AGENDA
FARRAGUT MUNICIPAL PLANNING COMMISSION

September 20, 2018
7:00 p.m. Farragut Town Hall

REPORT TO THE FARRAGUT MUNICIPAL PLANNING COMMISSION

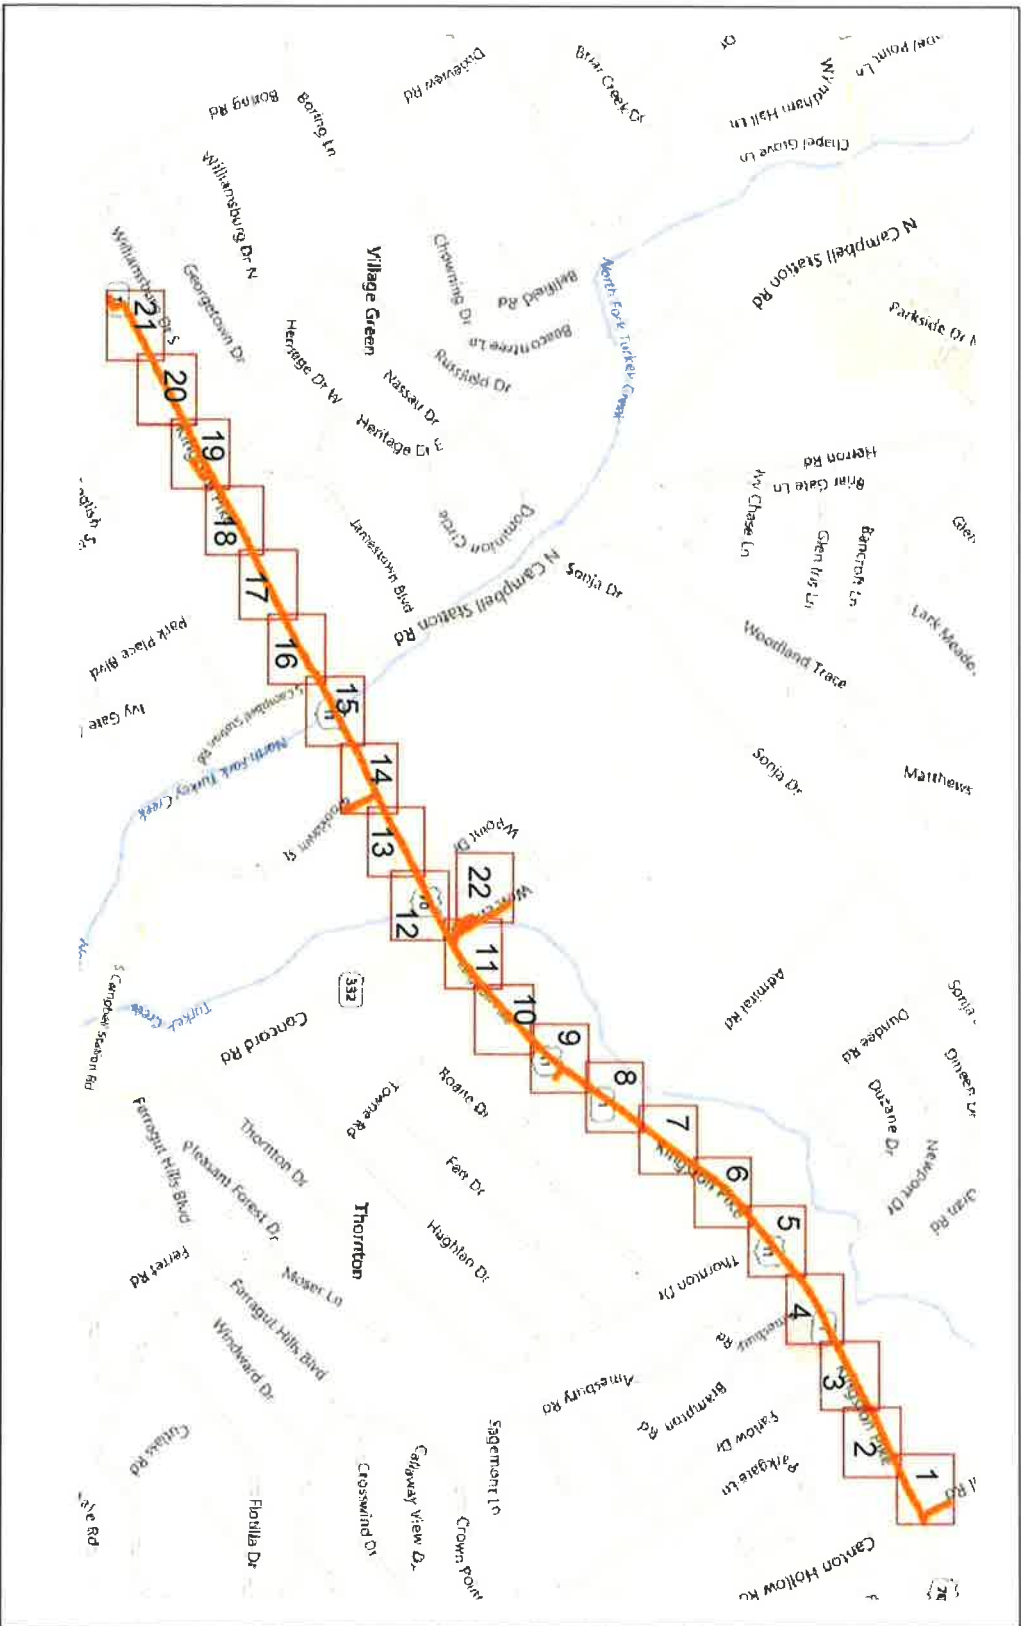
- 4) Please correct the title page to reflect the proper jurisdiction and include a schedule and scope of work on the title page;
- 5) Please label rights of ways and the outer limit of the 10-foot utility easement to demonstrate that all work will be within such areas;

- 6) Please darken the lines and enlarge and label all public streets so that all information is very legible;
- 7) A pre-construction meeting and right of way permit will be required with Town staff prior to initiation of work and once the plans have been approved by the Planning Commission; and

- 4) Please correct the title page to reflect the proper jurisdiction and include a schedule and scope of work on the title page; **Sent via email.**
- 5) Please label rights of ways and the outer limit of the 10 foot utility easement to demonstrate that all work will be within such areas; **See drawings**

- 6) Please darken the lines and enlarge and label all public streets so that all information is very legible; **See drawings**
- 7) A pre-construction meeting and right of way permit will be required with Town staff prior to initiation of work and once the plans have been approved by the Planning Commission; **We will schedule this post-approval.**

<i>ELLEN AMANDA CAMPBELL PROPERTY</i>		
SCALE: 1"= 100'	APPROVED BY: REL	DRAWN BY: RELj
DATE: 7-31-2018	LAST REVISION DATE: 9-10-2018	
DISTRICT 6 * TOWN OF FARRAGUT KNOX COUNTY * TENNESSEE		
TAX MAP 130, PARCELS 84.01, 84, & 87 SHEET 1 OF 1		DRAWING NO.: 5393-FP

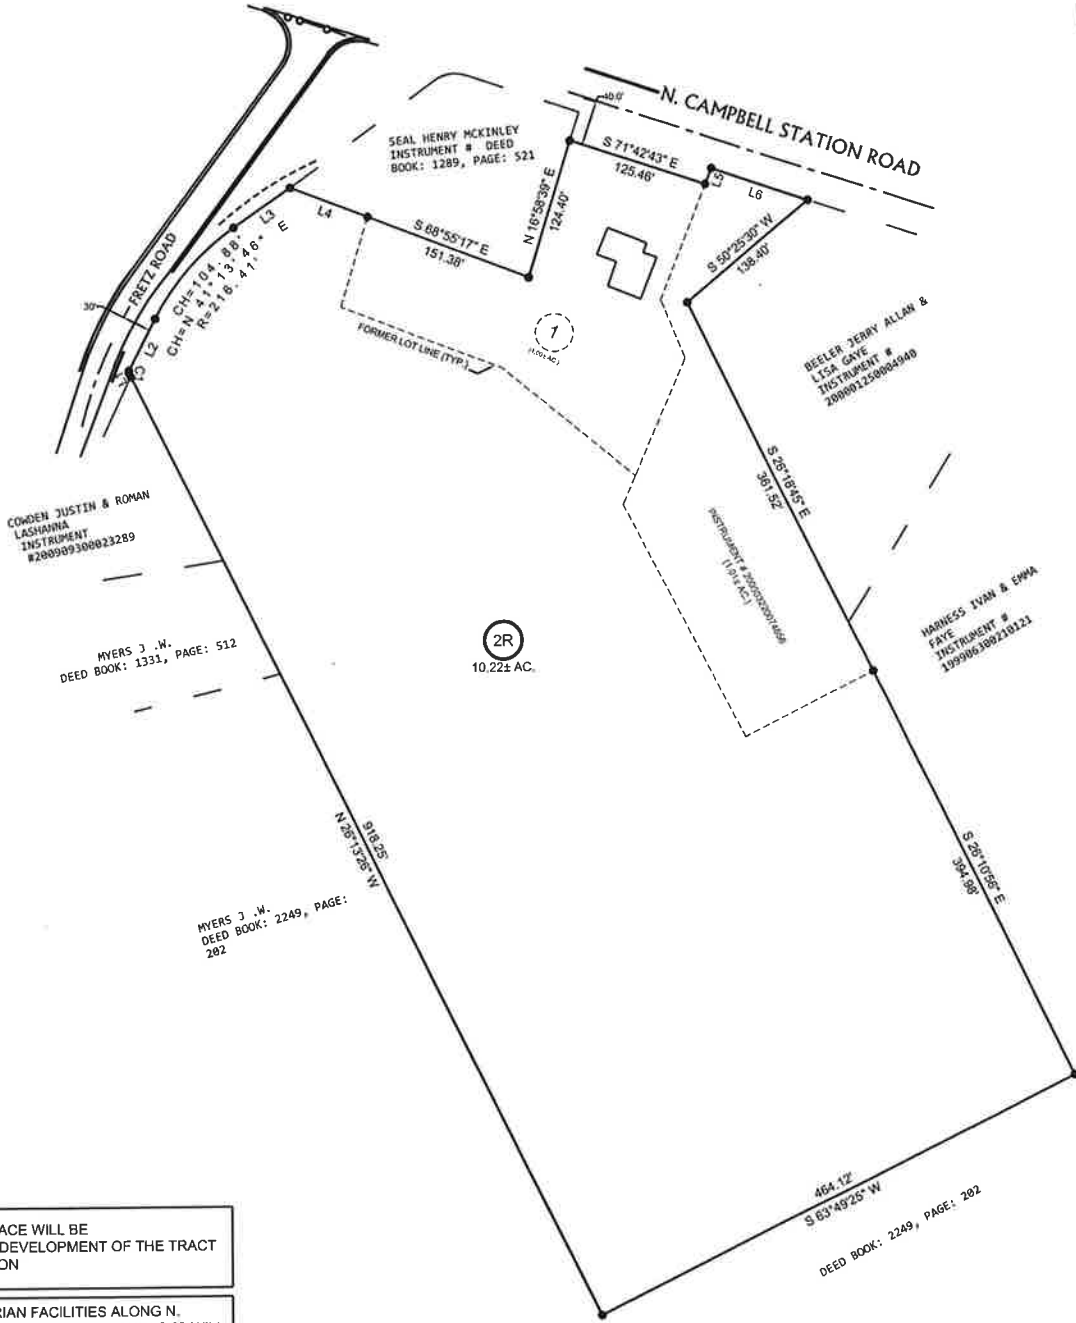
The staff has reviewed the resubdivision plat for the Ellen Amanda Campbell property at the east intersection of Fretz Road and N. Campbell Station Road and has compiled the comments below. **This item and the associated preliminary plat will be discussed at the Staff/Developer Meeting at the Farragut Town Hall on Tuesday, September 4, at 9:00 a.m.** The purpose of this meeting is to review questions you may have on staff comments. Though revisions are not due until Monday, September 10, when revisions are submitted, please include three (3) full size copies and one (1) 11" x 17" reduced set to the Farragut Town Hall. Upon resubmittal, please include a letter which addresses these comments and that indicates where the information can be found on the plans.

- 1) Please show the required right of way along Fretz Road (30 feet from centerline) and N. Campbell Station Road (40 feet from centerline) that will be dedicated with this plat;

- 2) Please include the correct map and parcel information;
- 3) Notes 4, 5, 7, and 8 are incorrect. Please revisit and revise;
- 4) The page number is missing from the deed book reference for the tract to the south;

- 5) Please include as a numbered note the purpose of the plat;
- 6) Please correct the title block to properly identify the parcels being resubdivided;

- 7) Is there more than one owner involved that would need to sign the plat?
- 8) Please show old acreages and lot #'s in parentheses;
- 9) The covenants and restrictions will be required as part of the final plat for the development of the resubdivided property. These will have to be approved by the Town attorney;

- 12) Please add a note to this plat which states that the required pedestrian facilities along the N. Campbell Station Road and Fretz Road frontages will be provided as part of the development of the tract created by this resubdivision.

Response to Staff comment sheet dated 8/29/2018

-
1. Right of Way updated on plat.
 2. Correct map and parcel information updated on plat.
 3. Notes 4, 5, 7, and 8 updated on plat.
 4. Page number and deed book reference for the tract to the south updated on plat.
 5. Numbered note stating the purpose of the plat added to plat.
 6. Title block to properly identify the parcels being resubdivided is corrected.
 7. Only one owner for the parcels in question.
 8. Old acreages and lot #'s in parentheses.
 9. Covenants and restrictions will be recorded.
 10. Release of easements certificate added.
 11. Open Space Note added.
 12. pedestrian facilities note added.

SHEET NO:
C-2.1

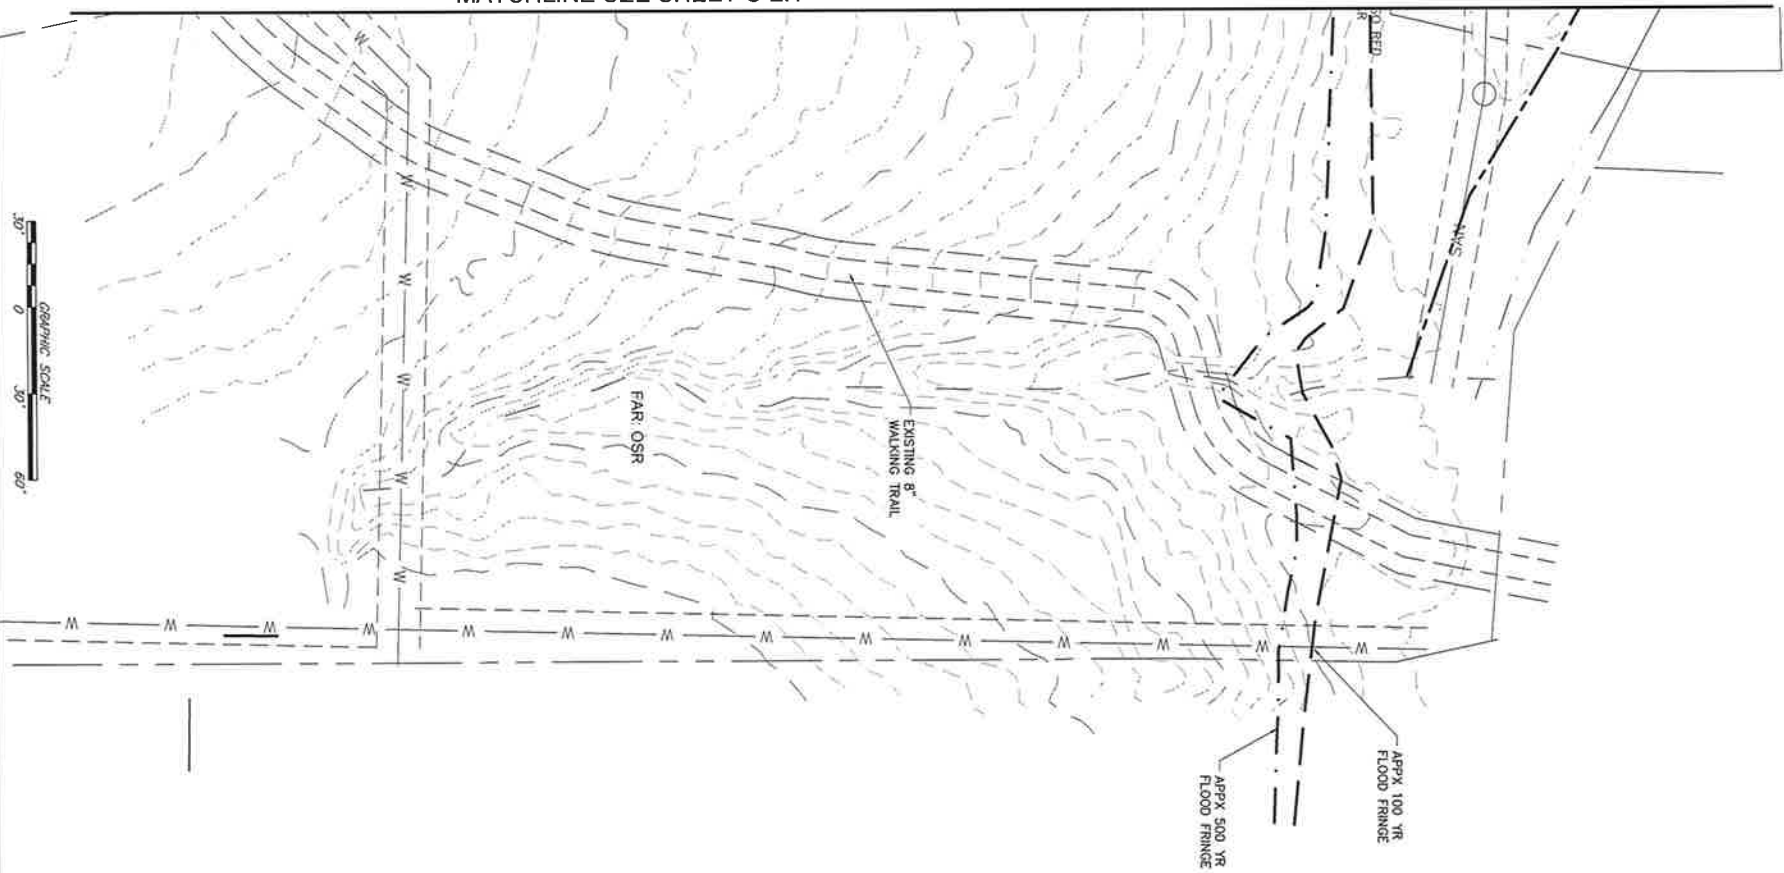
RESPONSE: The FW designation comes from the Knoxville Web Site – Property Map and Details Report and indicates the school district.
- 6) Sheet C-2.1 (concept Plan) uses the tax parcel number designations and lot number designations interchangeably and in different locations. Please clarify, it is confusing and may led to interpretation errors;
